DEVELOPMENT FACILITATION TEAM

Planning - Case Comments

Project Number: PR-2023-008552

Project Name: Central west of Cedar St.

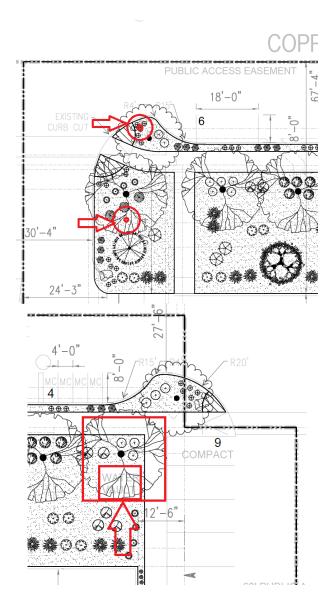
- \checkmark Per 5-6(C)(6) all vegetation sizes meet the minimum plant size requirements.
- Per 5-6(C)(7)(a) Vegetation required by this Section 14-16-5-6 shall be located at least 3 feet in any direction from any fire hydrants, valve vaults, hose bibs, manholes, hydrants, and fire department connections. Articulate how the proposed landscape plan complies with this code. If necessary, please make proper adjustments to the landscape plan in order to meet this code. Please see marked up plans below as examples.

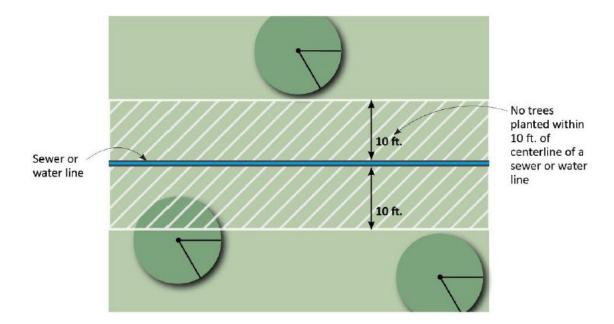
Per 5-6(C)(8) of IDO The clear sight triangle shall be maintained at all exits of parking areas and street intersections. Per 7-4(I)(5)(vi) of DPM, the following note is required on *(See additional comments on next page) all site plans: "Landscaping, signage, walls, fences, trees, and shrubbery between 3 feet and 8 feet tall (as measured from the gutter pan) are not allowed within the clear sight triangle."

Please show the site triangles on the landscape plan and identify that the ultimate size of the plant material planted in the site triangle areas will not be higher than 3 feet or if it is a tree, it has a canopy higher than 8-feet at the time of planting.

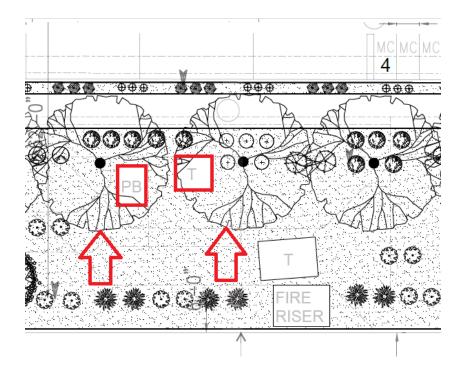
- Per 5-6(C)(10)(b) trees shall not be planted within 10 feet in any direction of the centerline of a sewer or water line. Please show the sewer and water lines on the landscape plan and demonstrate how the proposed landscape complies with this code. See figure below for more clarification.

- If overhead distribution electric lines are present please mark them up on the landscape plan and articulate how you meet 5-6(C)(10)(d)
- Per 5-6(C)(10)(e) all screening and vegetation surrounding ground-mounted transformers and utility pads must allow 10 feet of clearance for access and to ensure the safety of the work crews and public during maintenance and repair. Please consider moving trees away from the transformers to comply with this code. Below see marked up plan as an example.
